Drainage Proposals Report
for a
New Science Block at the Xavarian College,
Manchester
undertaken on behalf of
Xavarian College

Report Title:	Drainage Proposals Report for a New Science Block at the Xavarian College, Manchester
Report Reference:	10961 – Xavarian College – Science Block – Drainage Proposals - Rev 01
Client:	Xavarian College
Issue Date:	November 2023
Drafted By:	Kevin Tyldesley
Authorised By:	Loughlin O’Gorman

- 1.1 WML Consulting have been commissioned by the Xavarian College to provide a Drainage Proposals Report for a proposed development at their site at Lower Park Road, Manchester, M14 5RB.
- 1.2 In particular the report has been composed to respond to the drainage related planning condition (number 11) contained in Manchester City Council's planning approval notice ref. 137030/FO/2023, a copy of which can be found at appendix 01.

Typical detail drawing

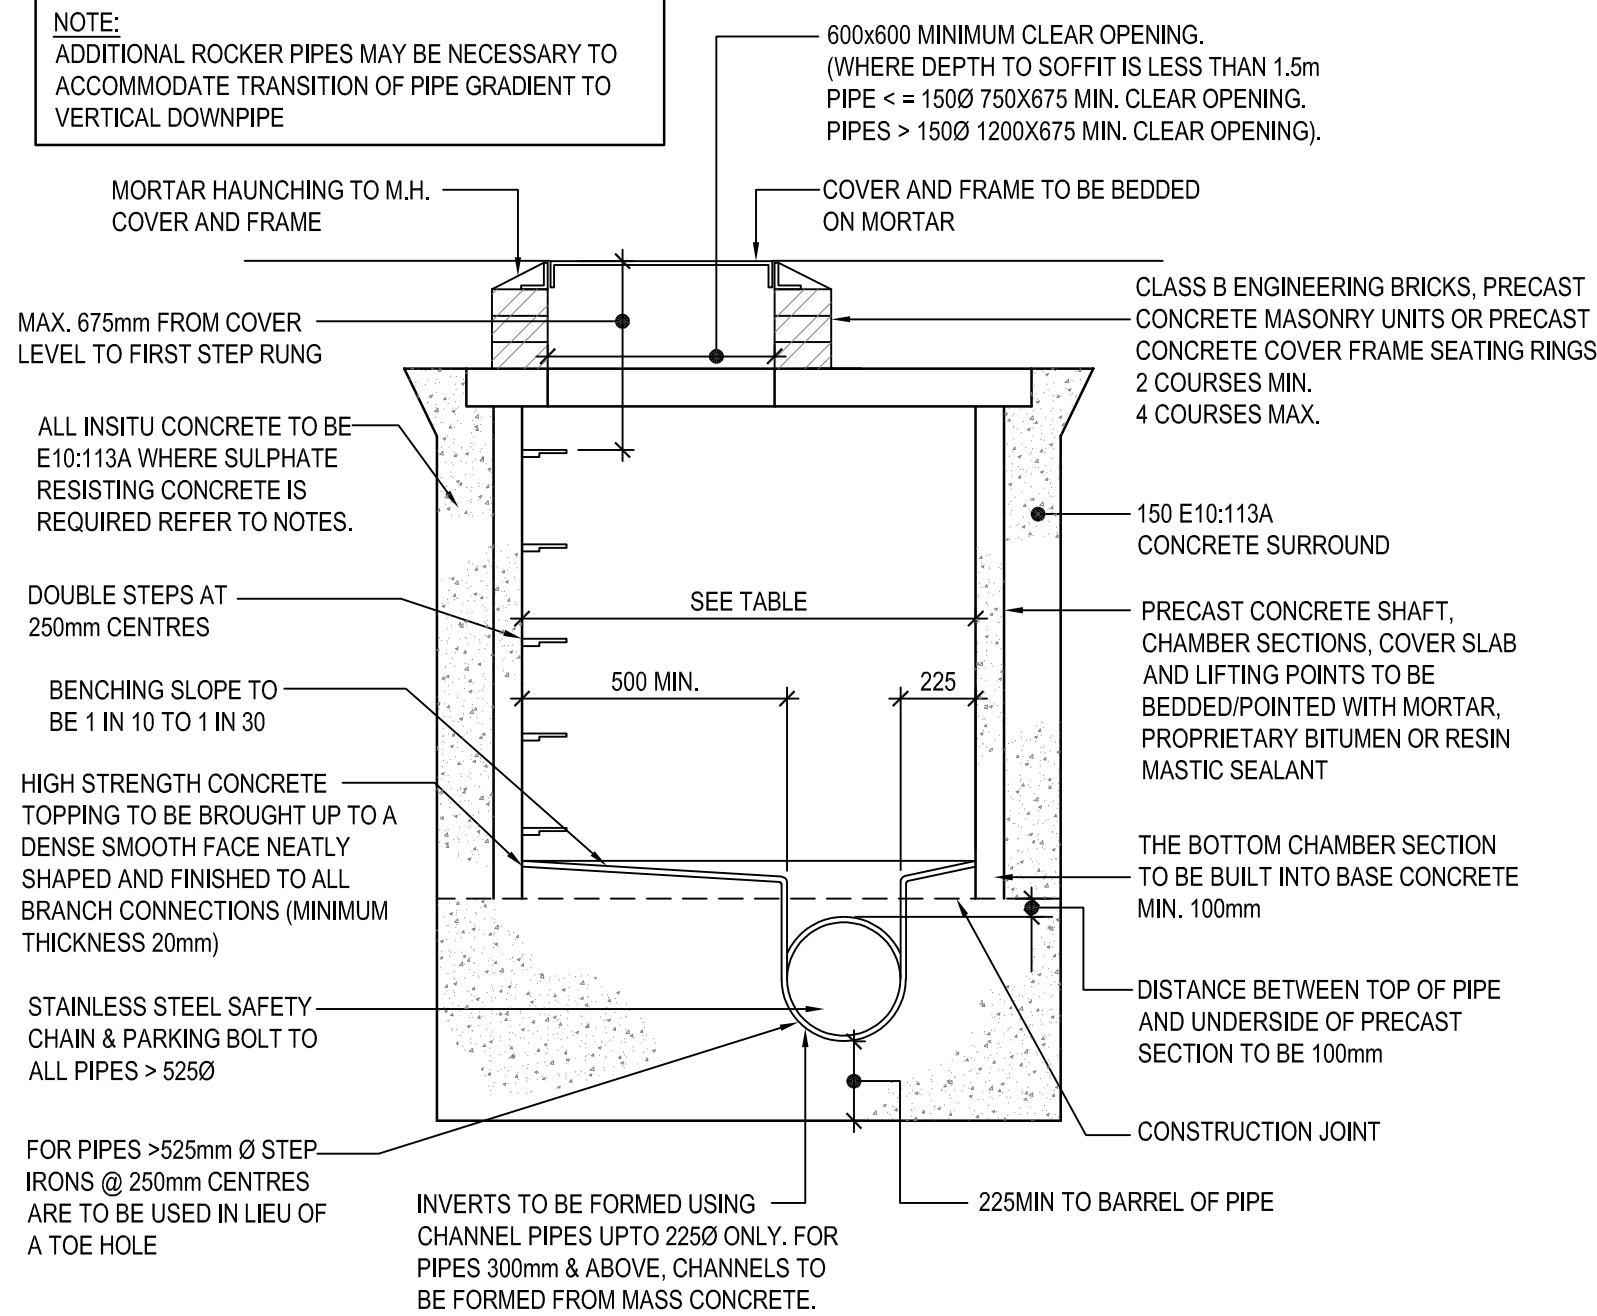
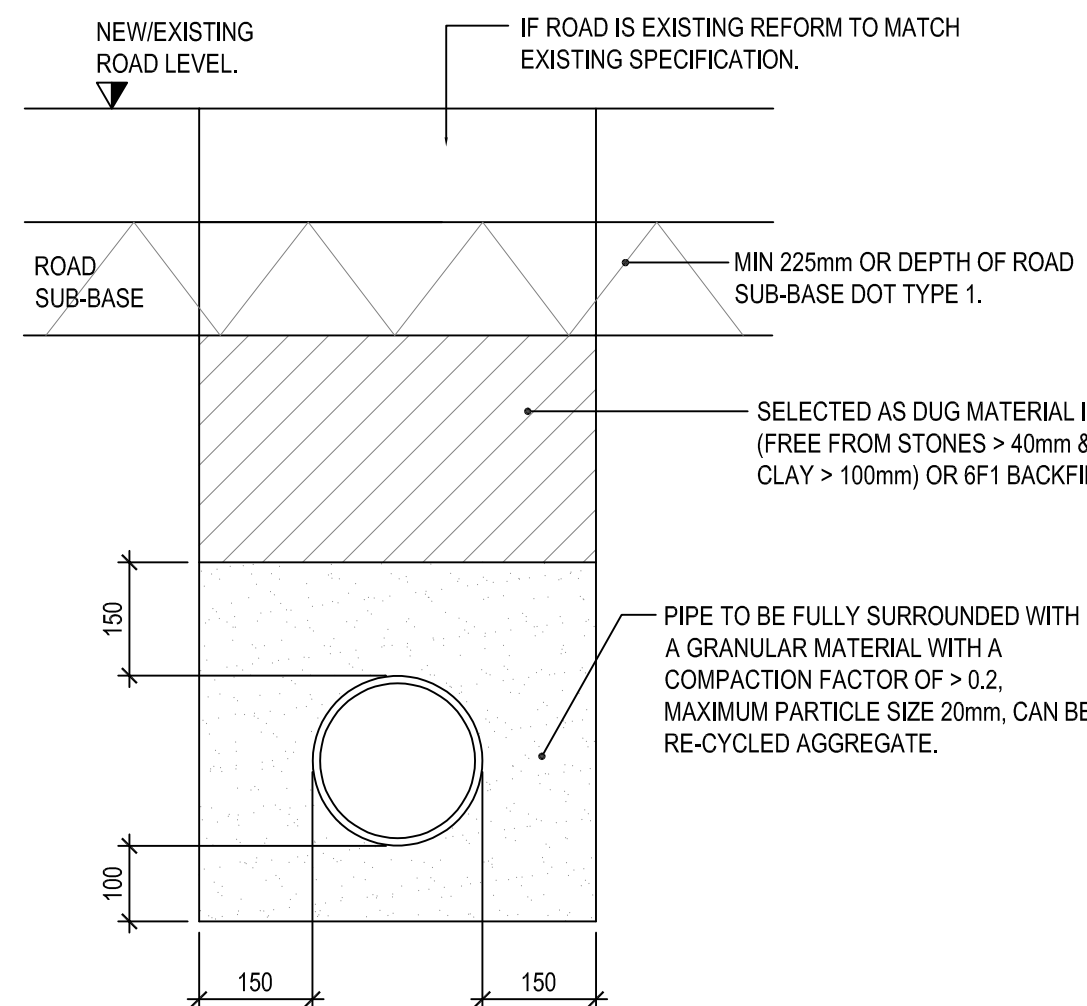
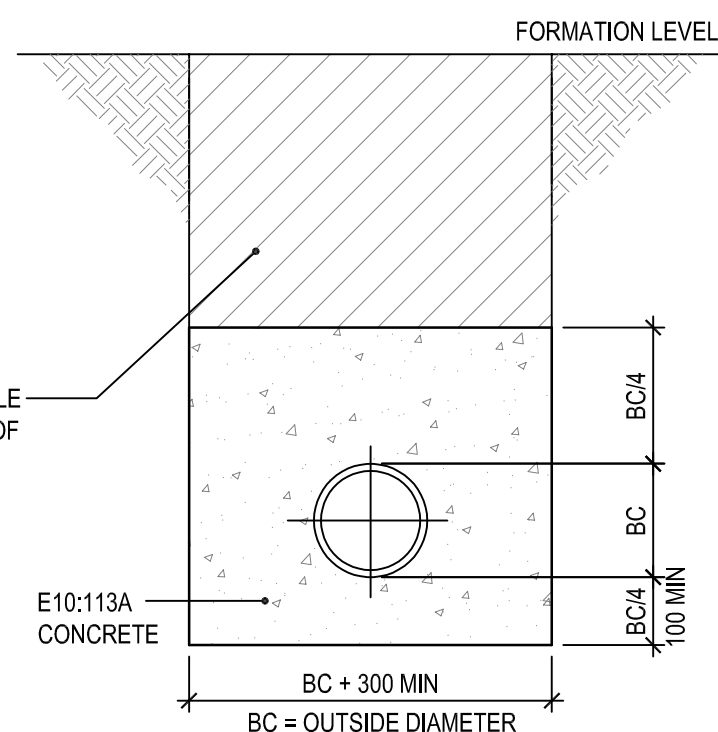
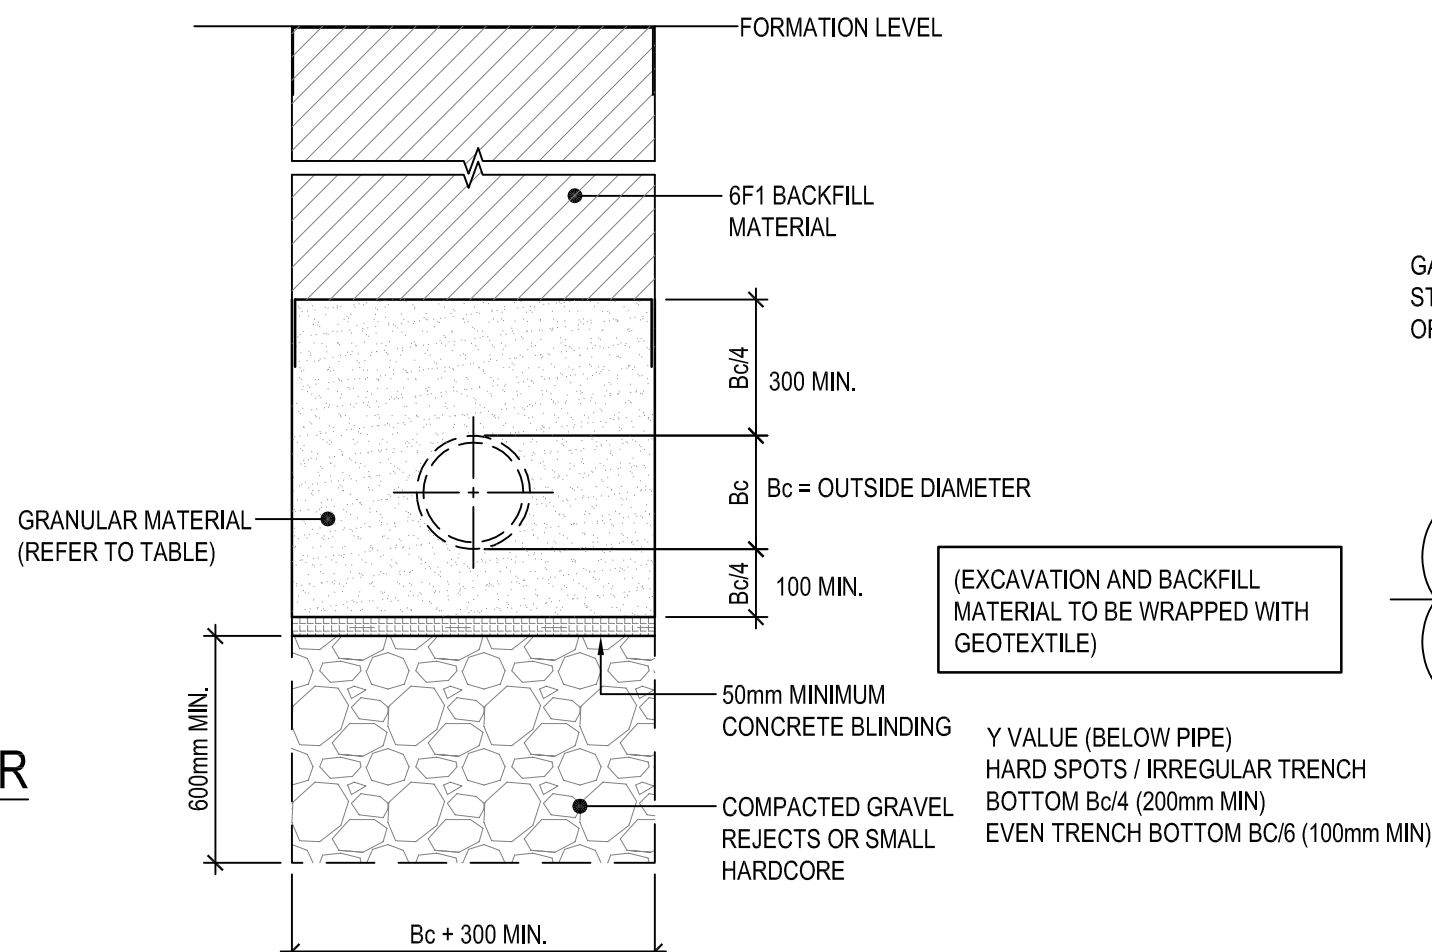
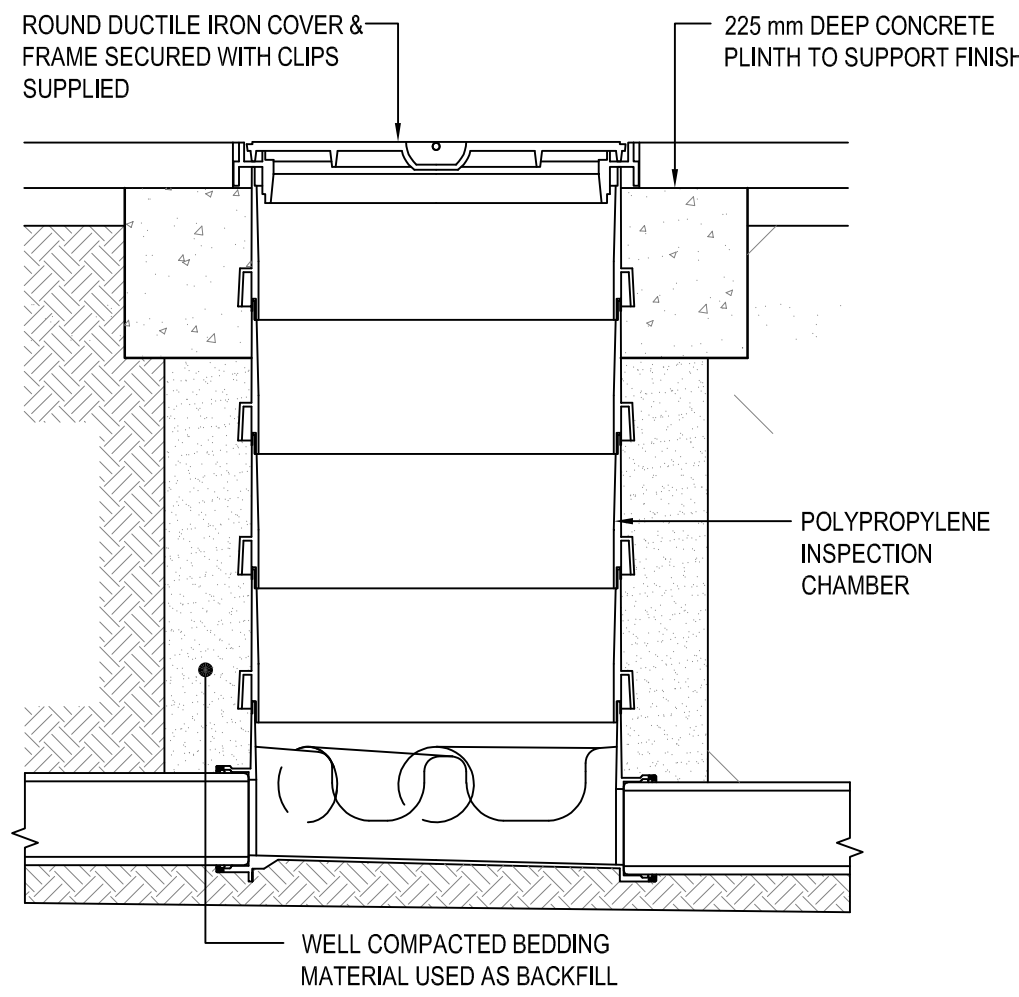
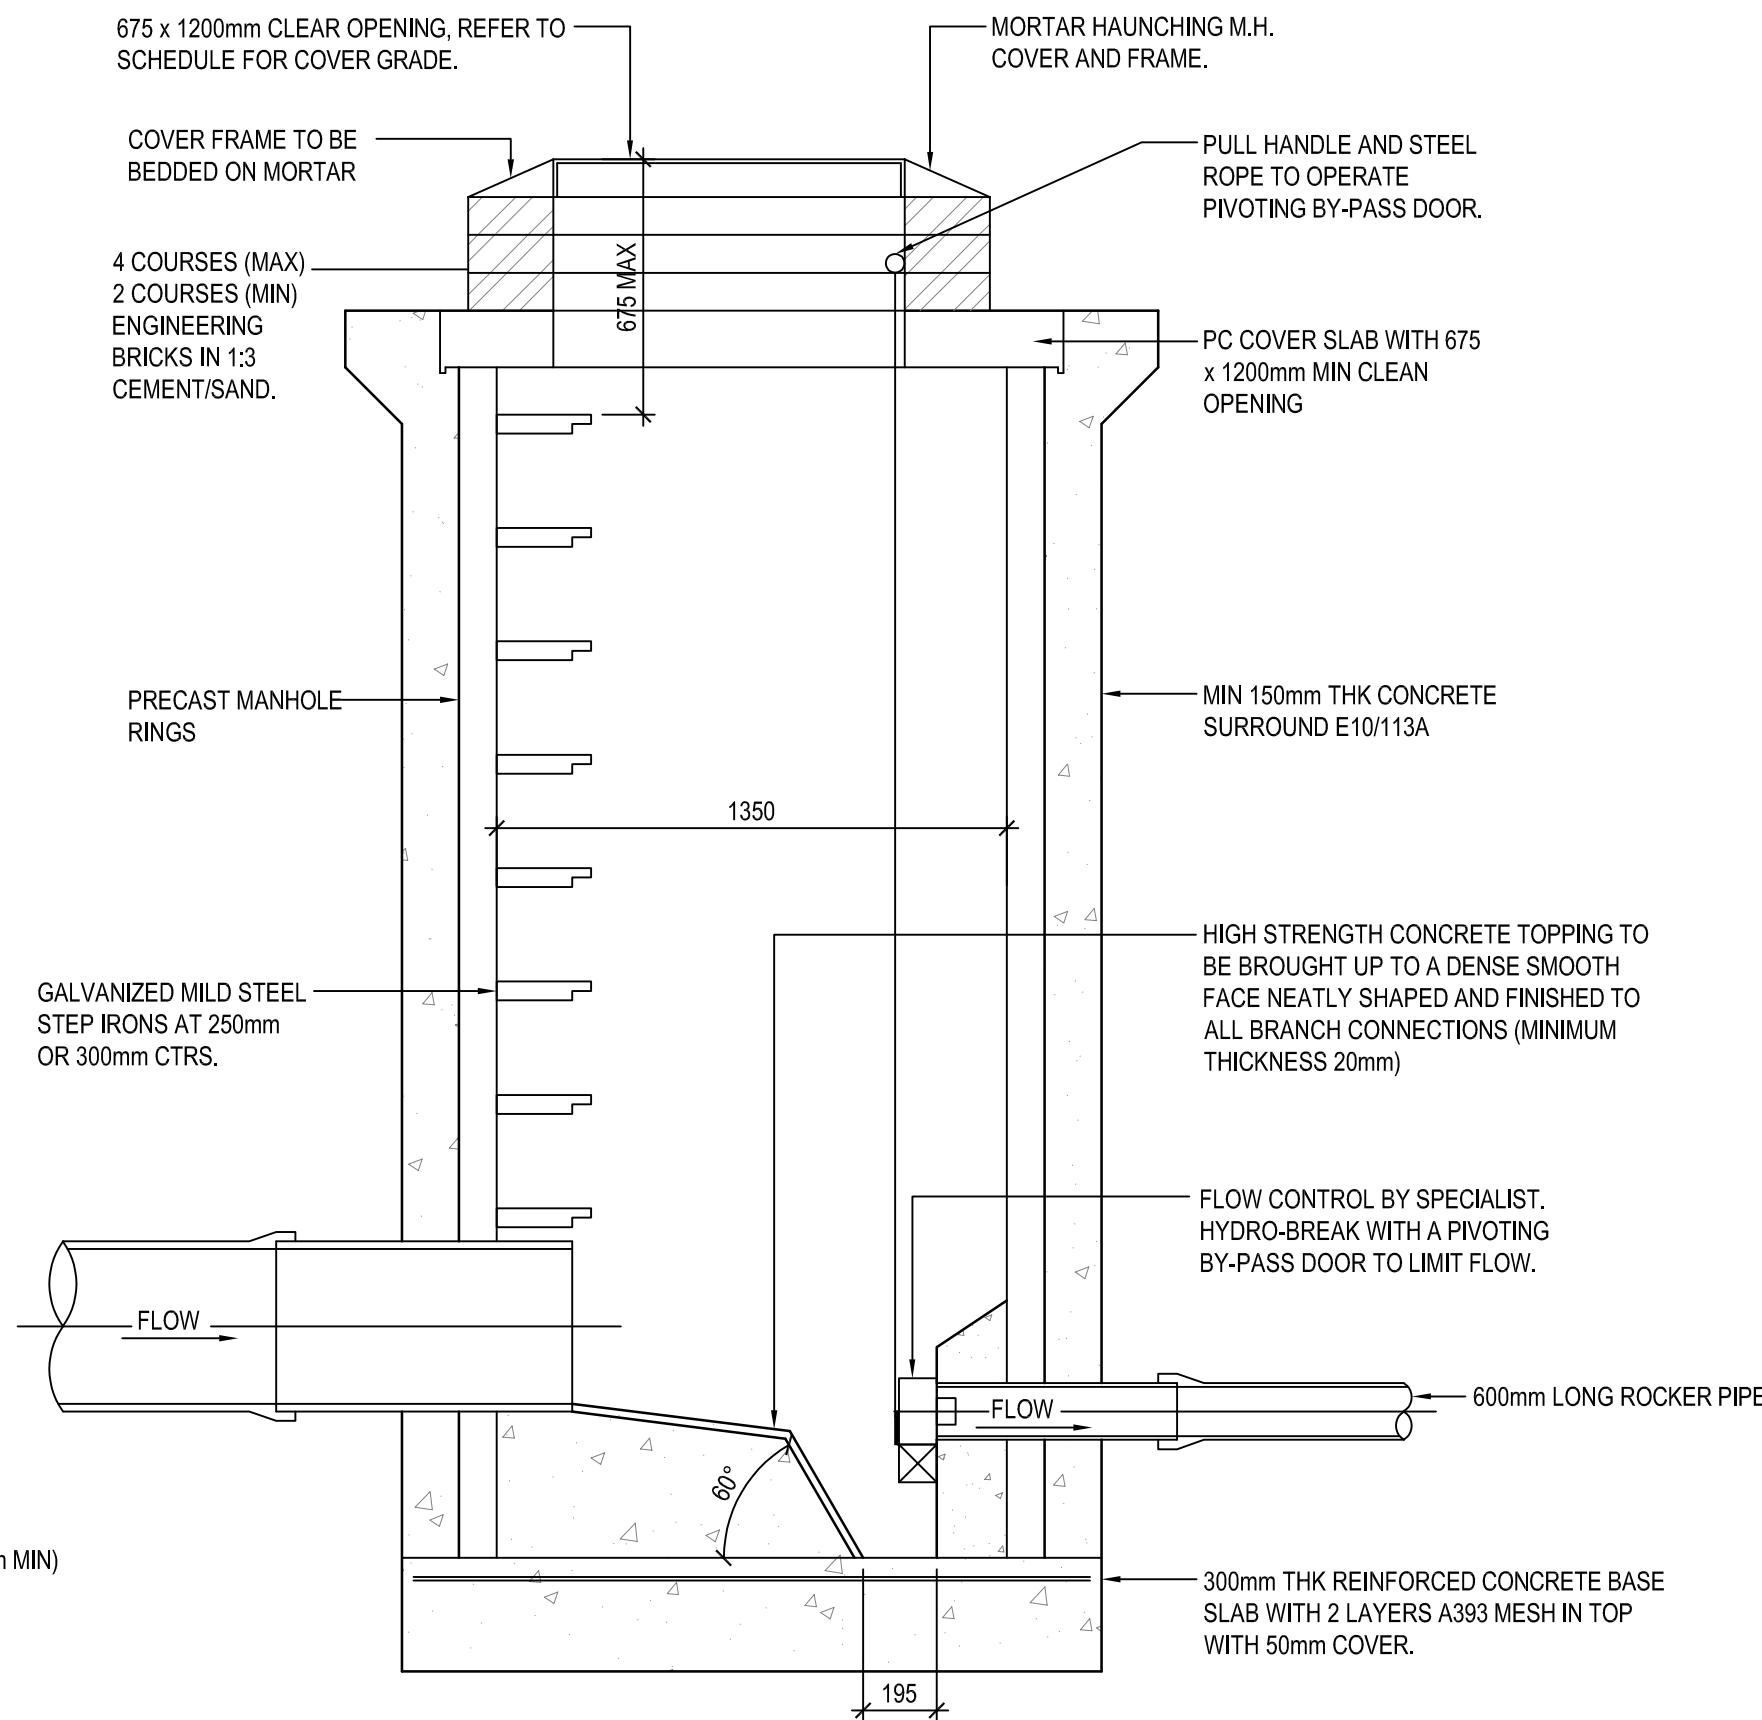
- For sites where proposed development would cause pollution risk to surface water, evidence of pollution control measures (preferably through SuDS) is required.
It is considered that the proposed development does not pose a significant risk of pollution to surface water.
- Hydraulic calculation of the proposed drainage system;
Refer to the drainage calculations at appendix 07.
- Construction details of flow control and SuDS elements.
Refer to the typical drainage detail drawing at appendix 08.
